To: T10 Technical Committee
 From: Rob Elliott, HP (elliott@hp.com)
 Date: 19 June 2006
 Subject: 06-189r2 SAS-2 Allow table-to-table expander attachment

Figure 1 — Table-to-table example

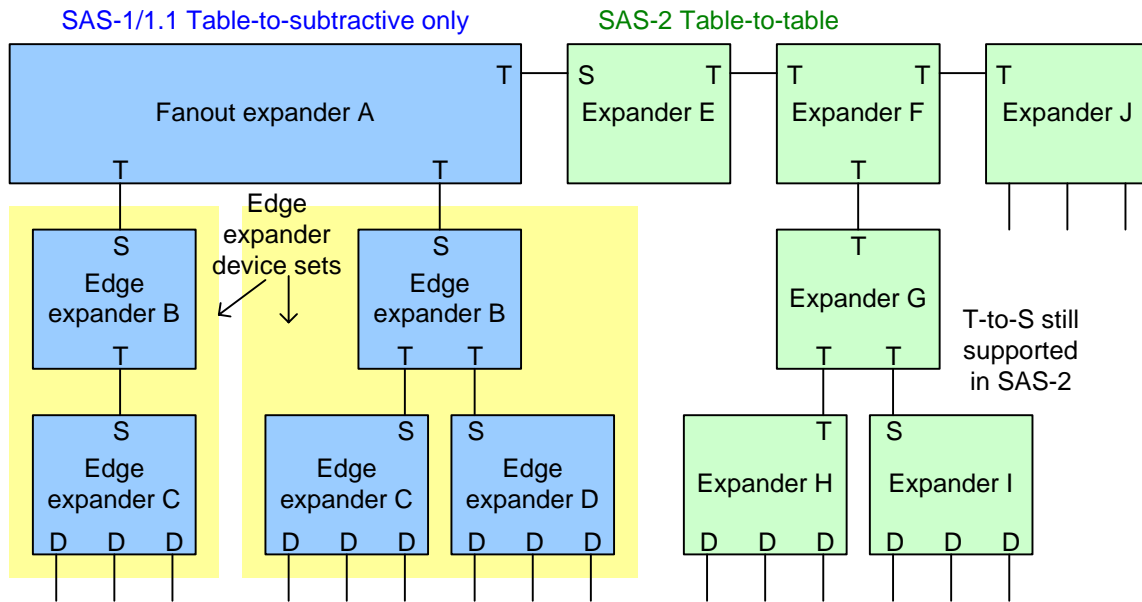
- c) Allow table-to-table attachments for self-configuring expander devices
 - A) Continue to prohibit this for externally configurable expander devices, so the SAS-1.1 discovery and configuration algorithms are unaffected

Figure 1 shows a basic example.

Figure 5 — Edge expander device set [delete this figure]

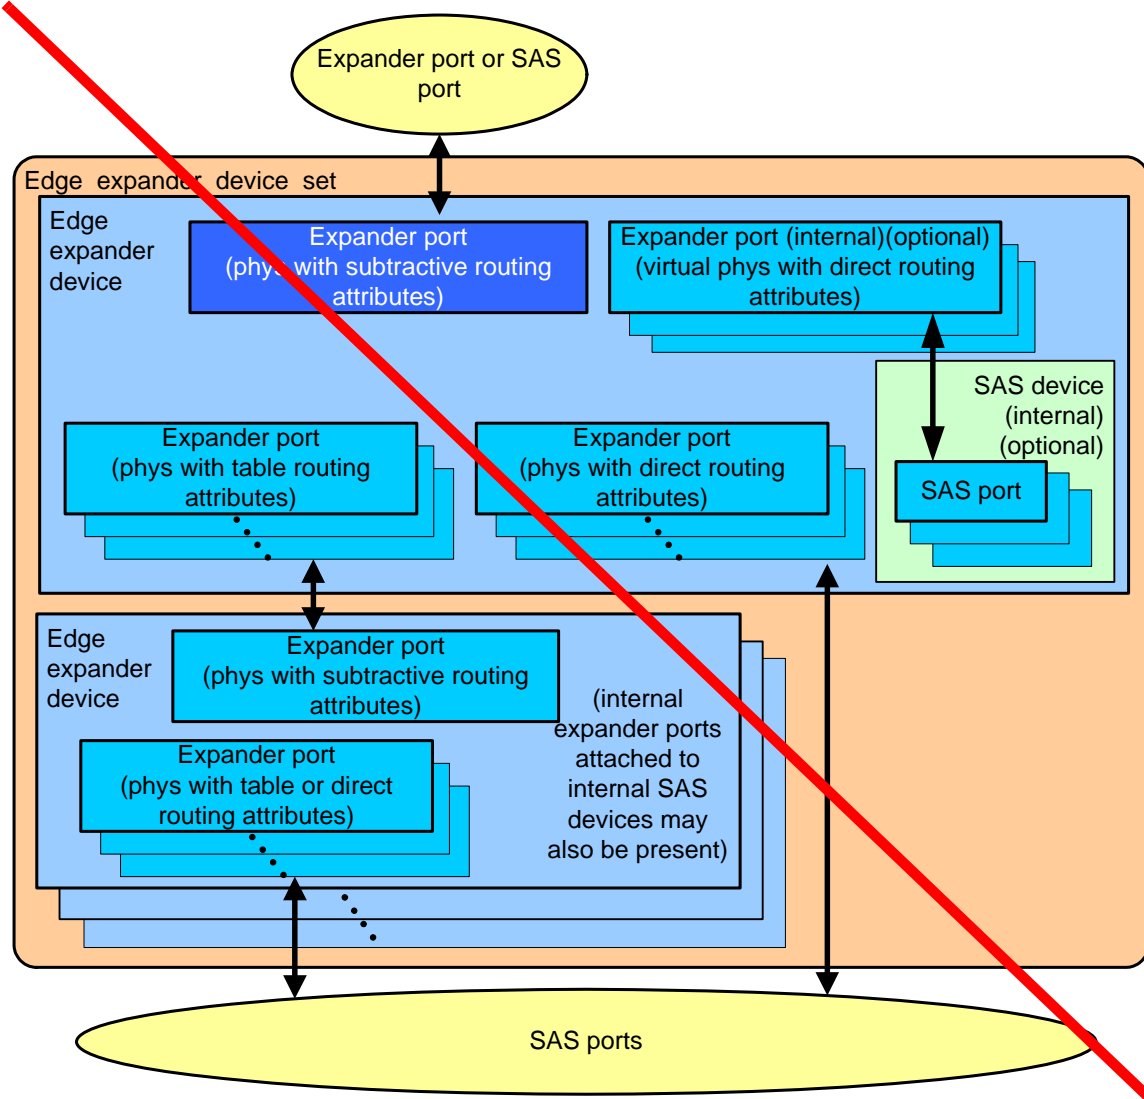
Figure 5 shows an edge expander device set.

Figure 6 — ~~Maximum expander device set topology~~ [\[delete this figure\]](#)

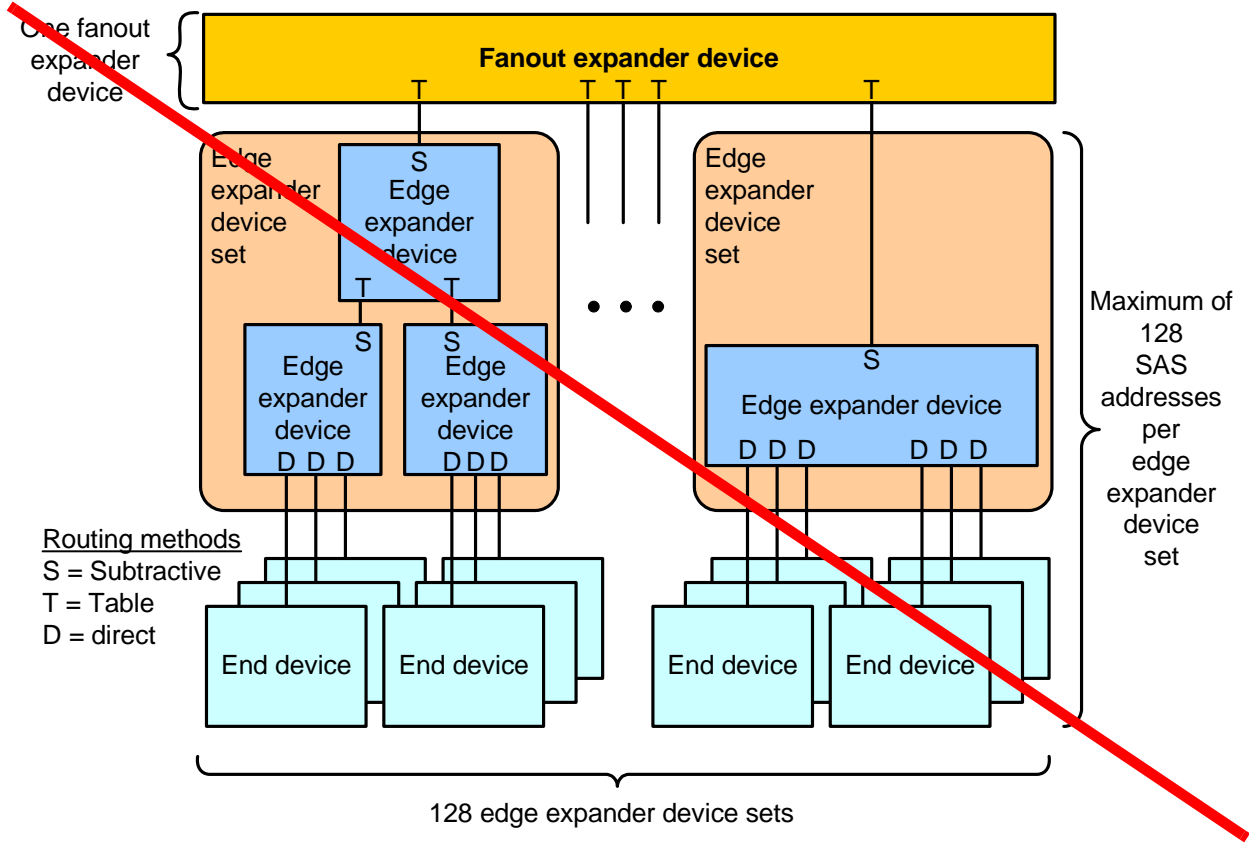
No more than one fanout expander device shall be included in a SAS domain. The fanout expander device may be attached to up to 128 edge-expander device sets or SAS ports.

Figure 6 shows a SAS domain with the maximum number of expander device sets.

Figure 7 — Fanout expander device topology [delete this figure]

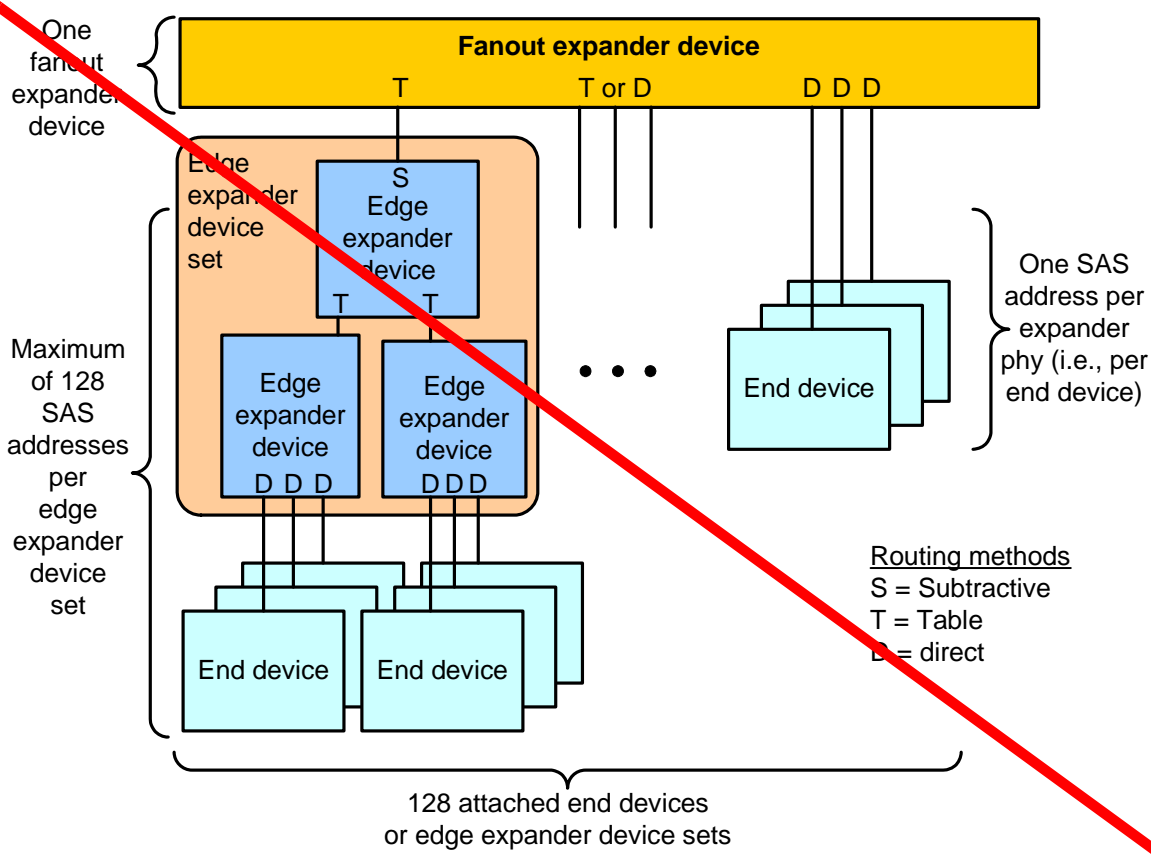
End devices may be attached directly to the fanout expander device, as shown in figure 7.

Figure 8 — Edge expander device set to edge expander device set topology [\[delete this figure\]](#)

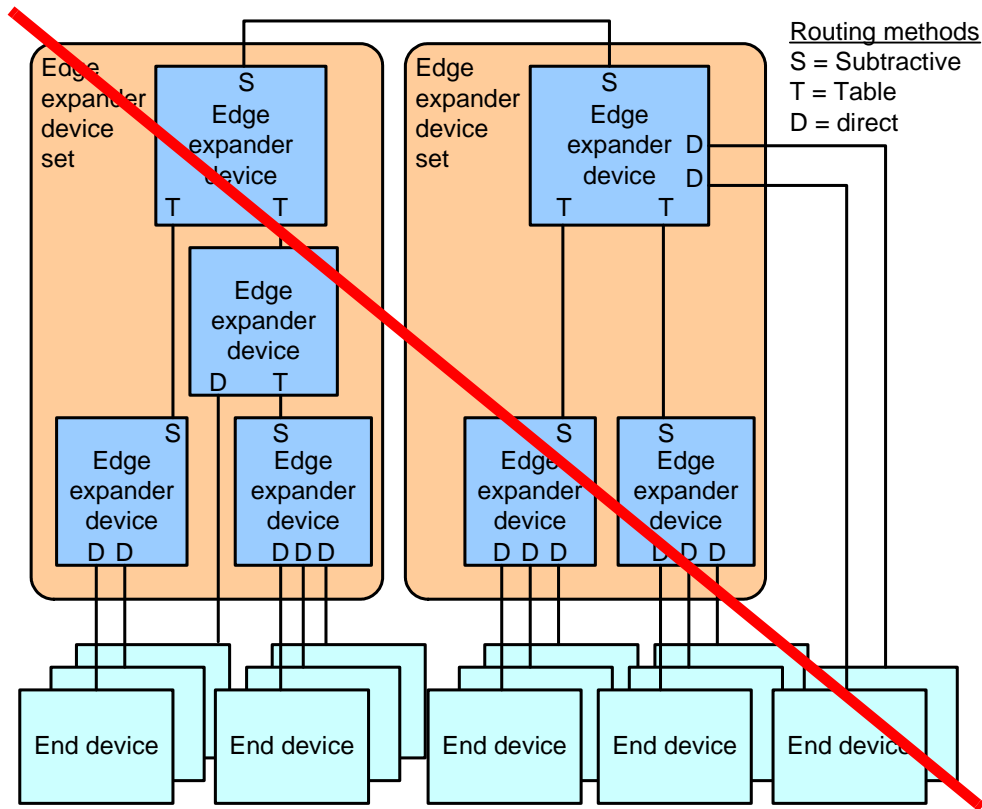
SAS initiator devices and SAS target devices may be attached to any of the edge expander devices within an edge expander device set and at most, two edge expander device sets may be attached together without a fanout expander, as shown in figure 8.

Figure 12 — Level-order traversal example [changed to include “self-configuring”]

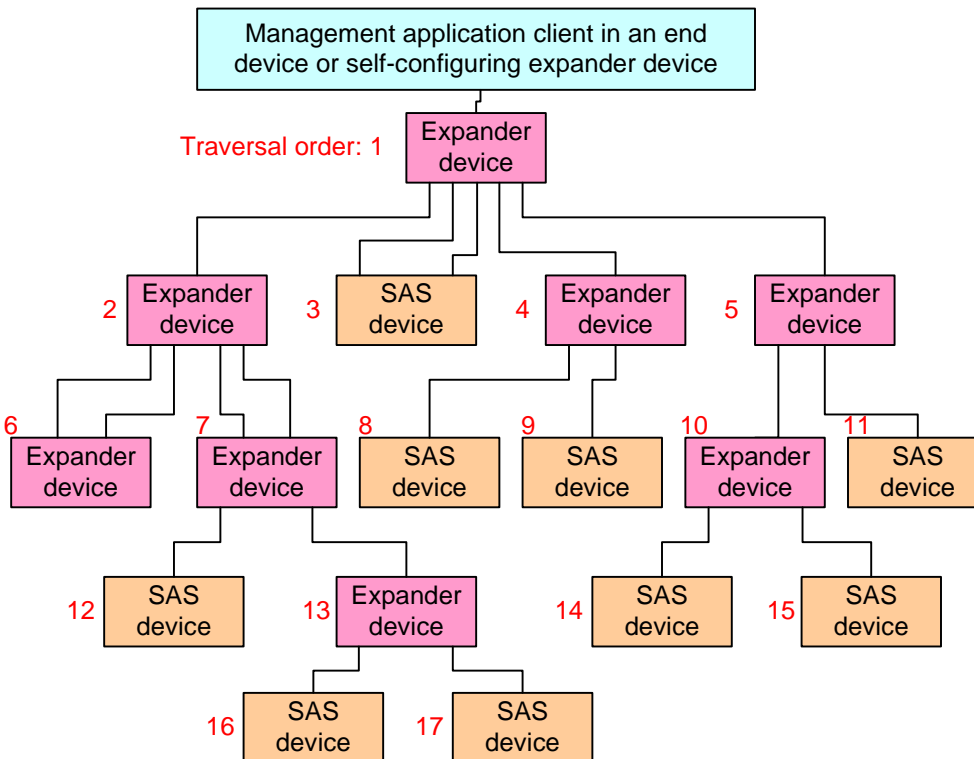
Figure 12 shows an example of level-order traversal.

Figure 15 — Expander route index levels example [TODO delete "edge"]

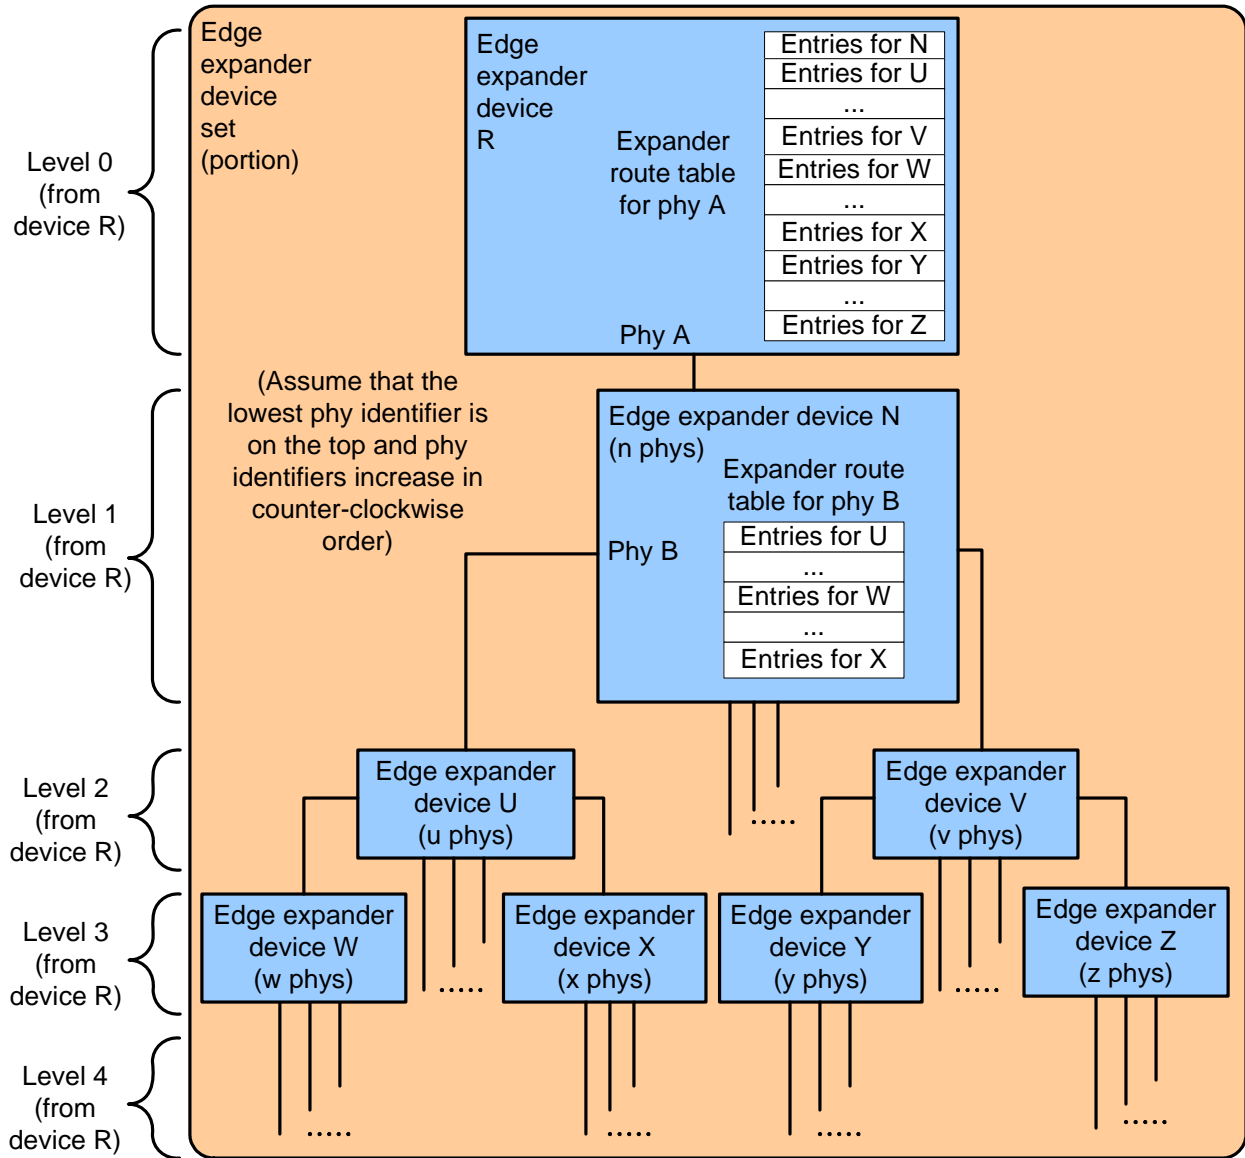
Figure 15 shows a portion of an edge expander device set SAS domain, where phy A in edge expander device R is being configured.

Figure 16 — Expander route index levels example with ~~fanout~~ expander device [TODO update]

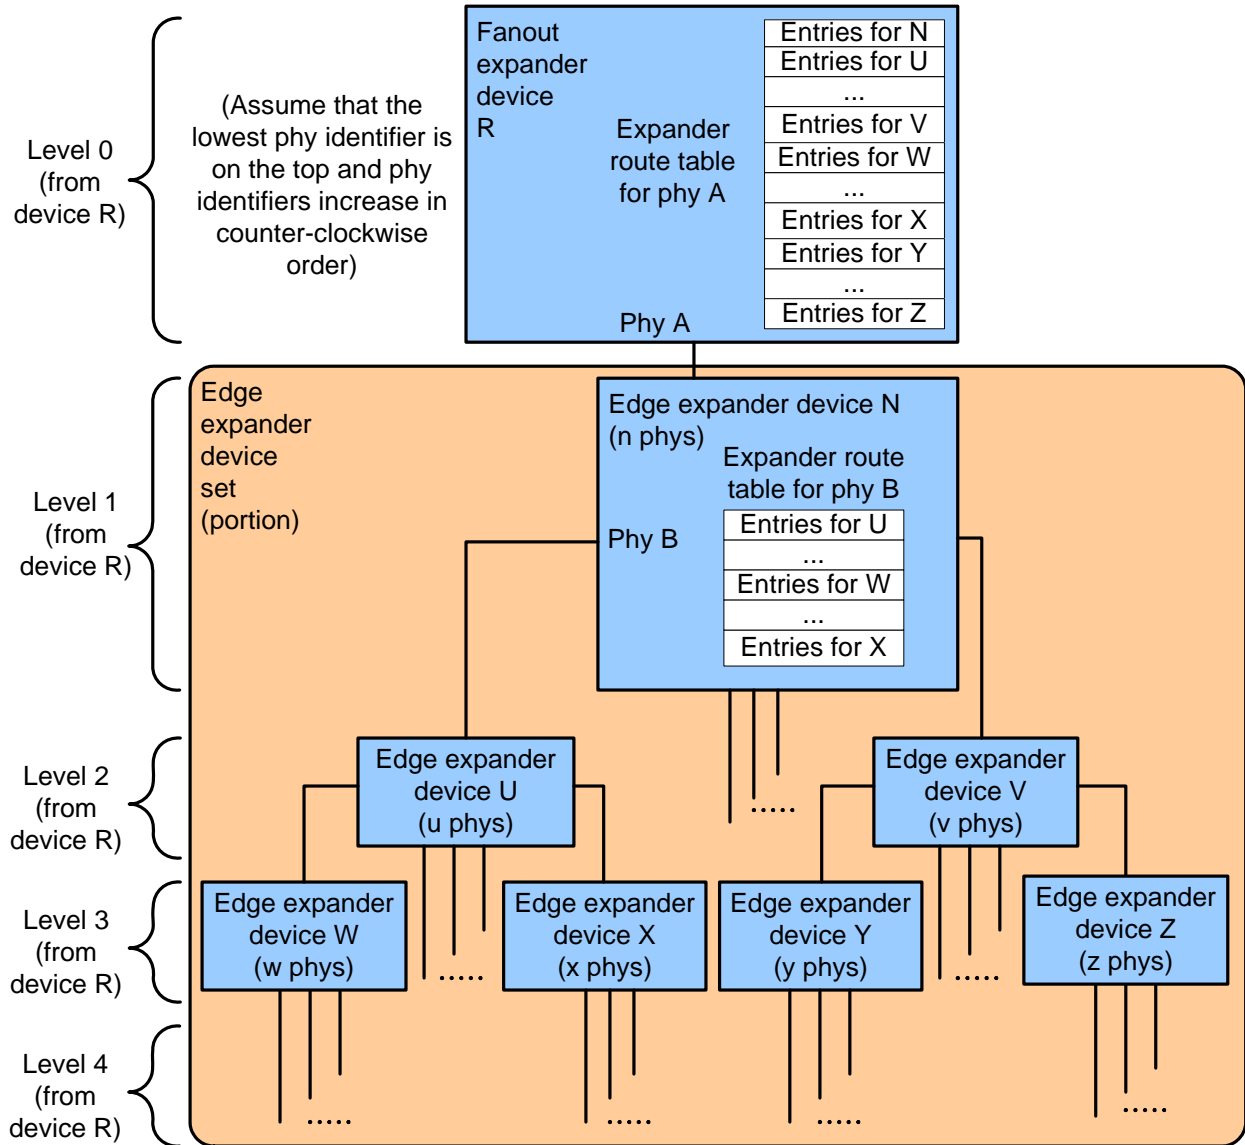
Figure 16 shows a ~~fanout expander device and an edge expander device set~~, SAS domain where phy A in the ~~fanout~~ expander device R is being configured.

Figure 17 — Expander route index order example

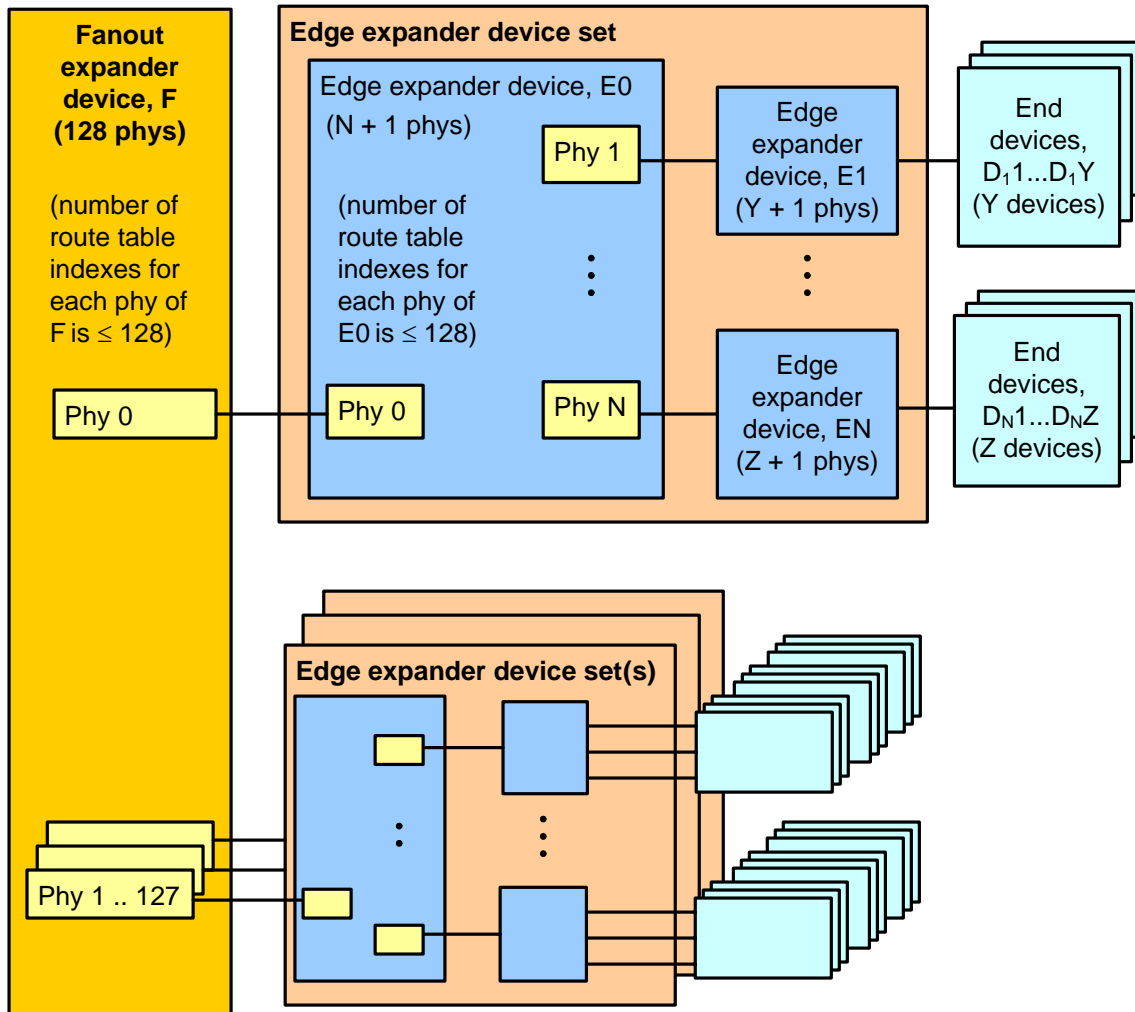
Figure 17 shows an example topology ~~with a fanout expander device.~~

Table 4 shows the expander route index order for ~~the edge~~ expander E0 phy 1 in figure 17.

Table 5 shows the expander route index order for ~~the fanout~~ expander F phy 0 in figure 17.

Figure 18 — Mini SAS 4x cable plug connector that attaches to an enclosure out port

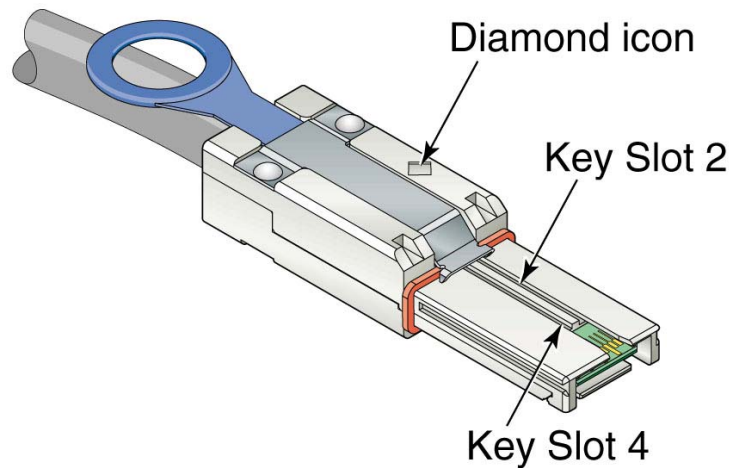
Figure 18 shows the key slots on the Mini SAS 4x cable plug connector that attaches to either an end device (see figure 20 in 5.2.3.3.2.2) or an enclosure out port (see figure 21 in 5.2.3.3.2.2) or an enclosure universal port.

Figure 19 — Mini SAS 4x cable plug connector that attaches to an enclosure in port

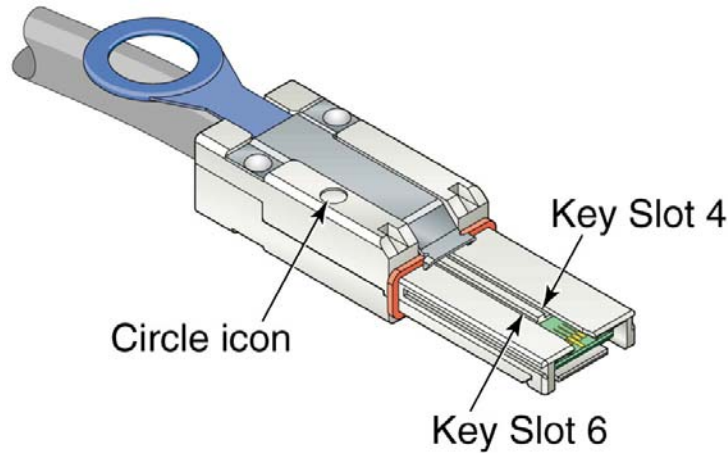
Figure 19 shows the key slots on the Mini SAS 4x cable plug connector that attaches to either an end device (see figure 20 in 5.2.3.3.2.2), ~~or~~ an enclosure in port (see figure 22 in 5.2.3.3.2.2), or an enclosure universal port.

Figure 20 — Mini SAS 4x receptacle connector - end device or enclosure universal port

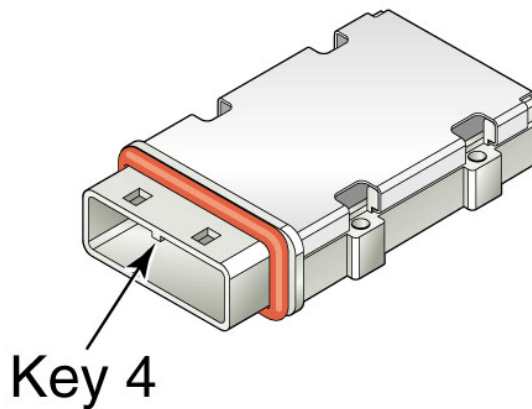
Figure 20 shows the key on a Mini SAS 4x receptacle connector used by end devices. This connector may be attached to the Mini SAS 4x cable plug shown in figure 18 or the Mini SAS 4x cable plug shown in figure 19 (see 5.2.3.3.2.2).
